Re: Letter of Notification of Mid-Atlantic Interstate Transmission, LLC for Approval of the Hilltop–Krayn–Rachel Hill 115 Kilovolt Transmission Line Reconfiguration Project in Richland Township, Cambria County, Pennsylvania
Docket No. A-2025-3058575

Enclosed please find the responses of Mid-Atlantic Interstate Transmission, LLC (“MAIT”) to the Data Requests issued by the Bureau of Technical Utility Services (“TUS”) on November 18, 2025, in the above-referenced matter.

Letter of Notification of Mid-Atlantic Interstate Transmission, LLC for the Hilltop – Krayn – Rachel Hill 115 kV Transmission Line Switch Replacement Project in Cambria County, Pennsylvania.

<small>Mid-Atlantic Interstate Transmission, LLC A FirstEnergy Company</small>	Hilltop - Krayn - Rachel Hill 115 kV Transmission Line Reconfiguration Project
GENERAL PROJECT LAYOUT	
EXHIBIT 3

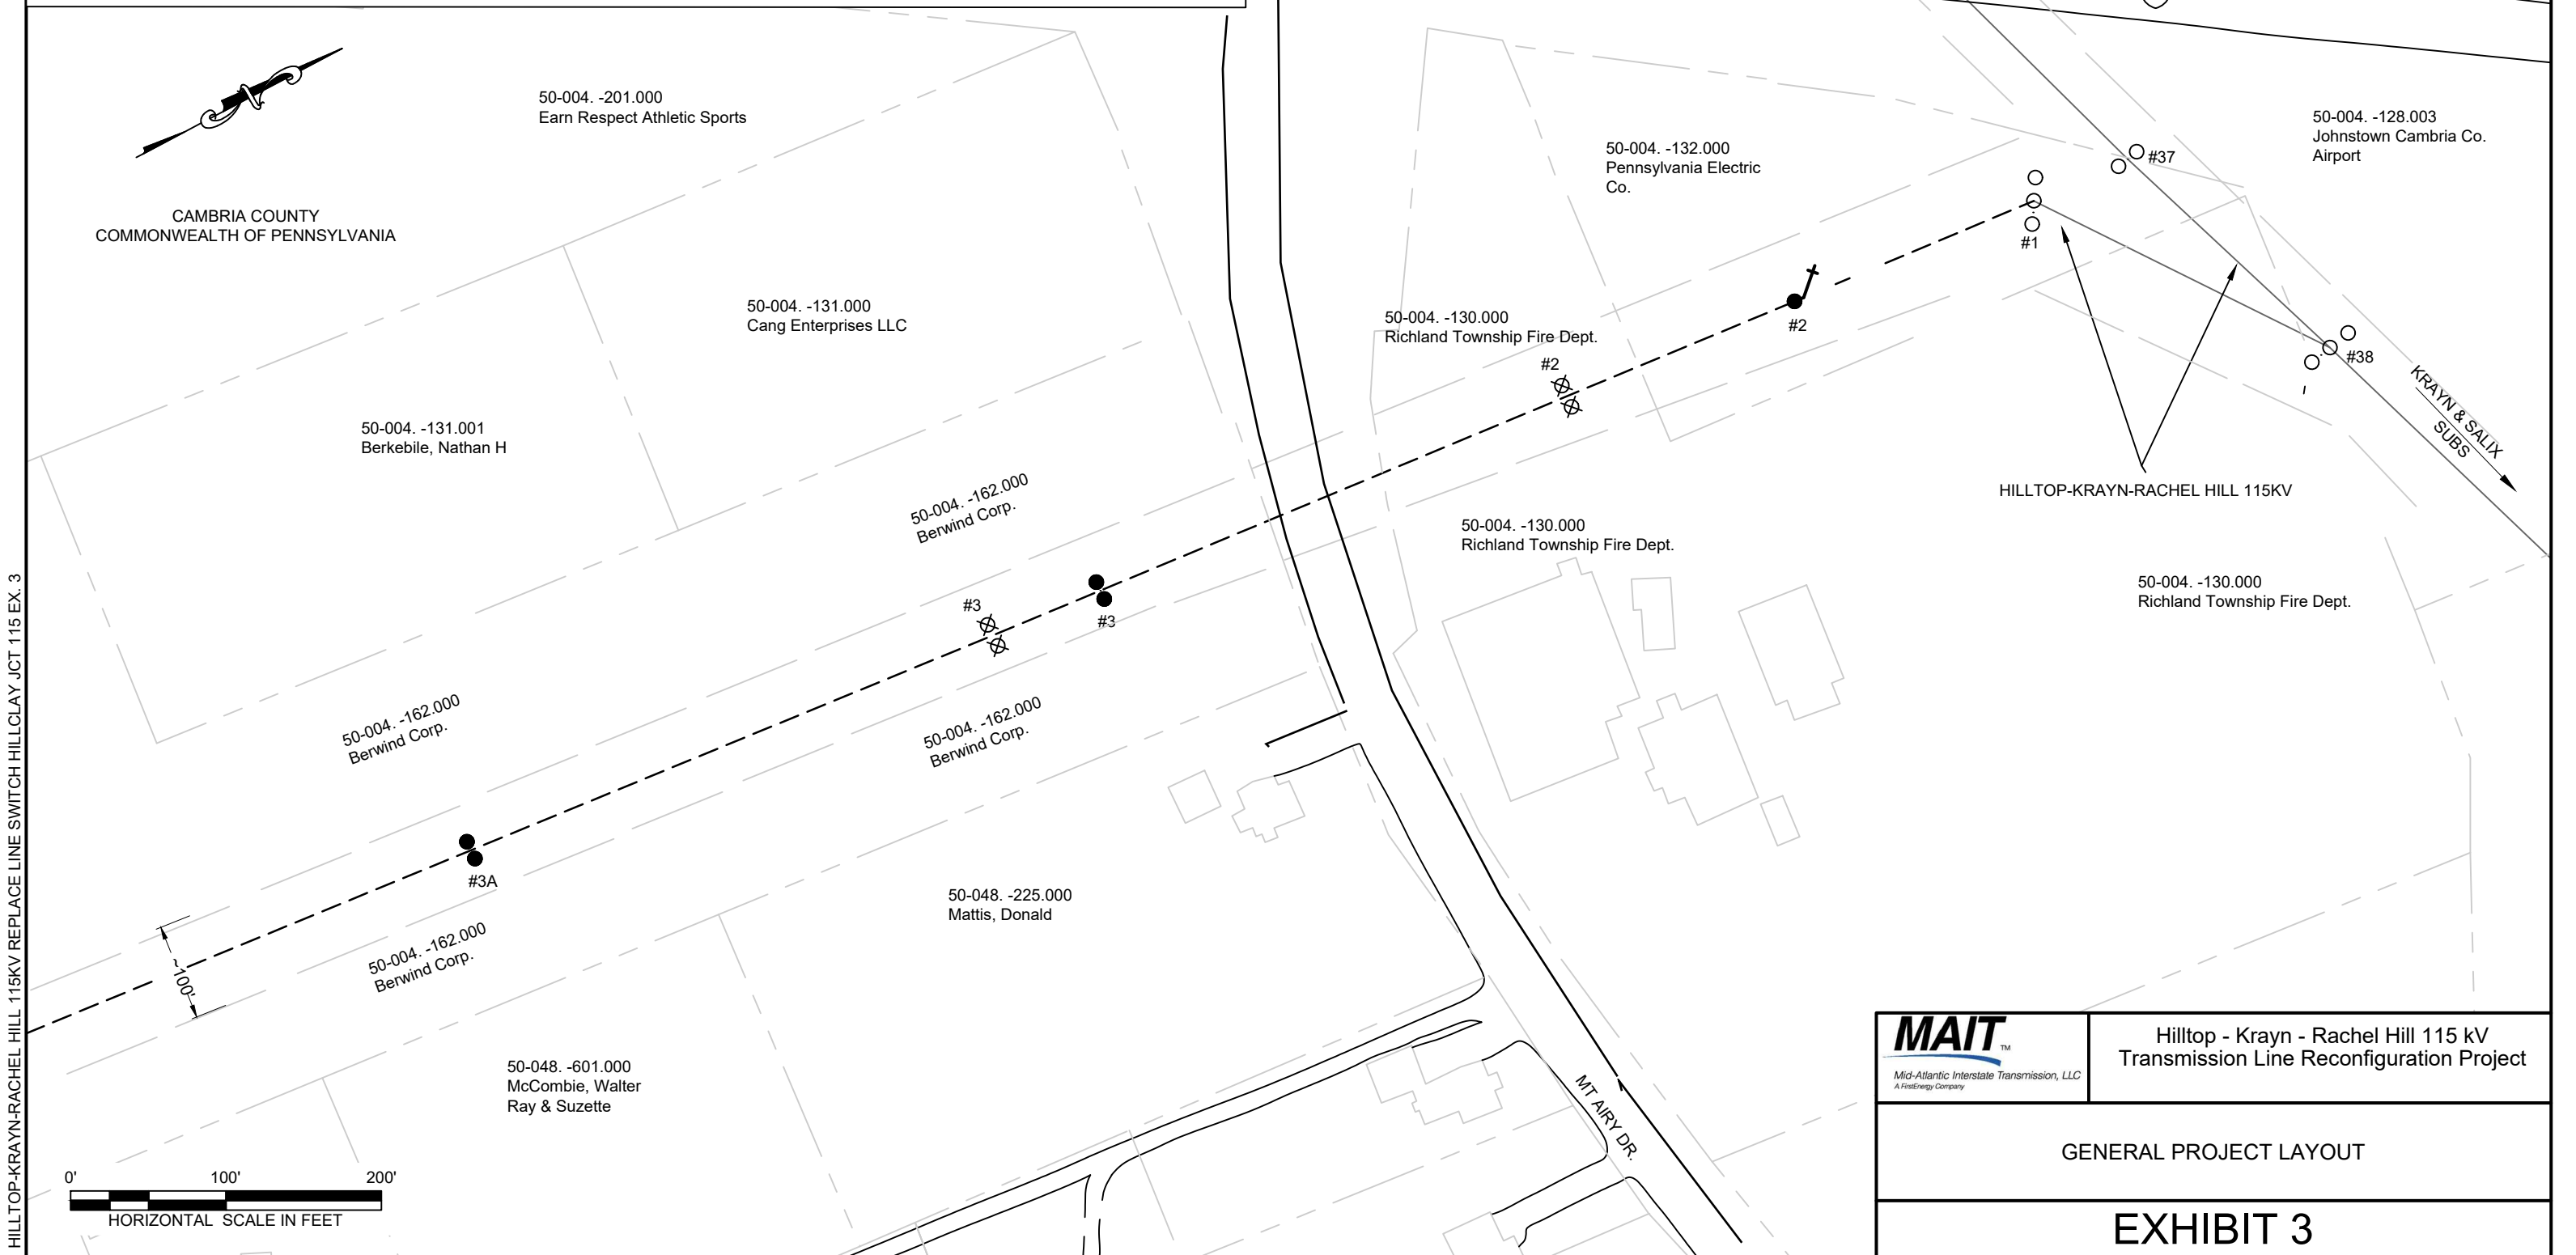
Reference the Letter of Notification, Exhibit 2. Please provide a copy of Exhibit 2 which shows the names of all property owners along the subject right-of-way.

Please see updated attached Exhibit 2.
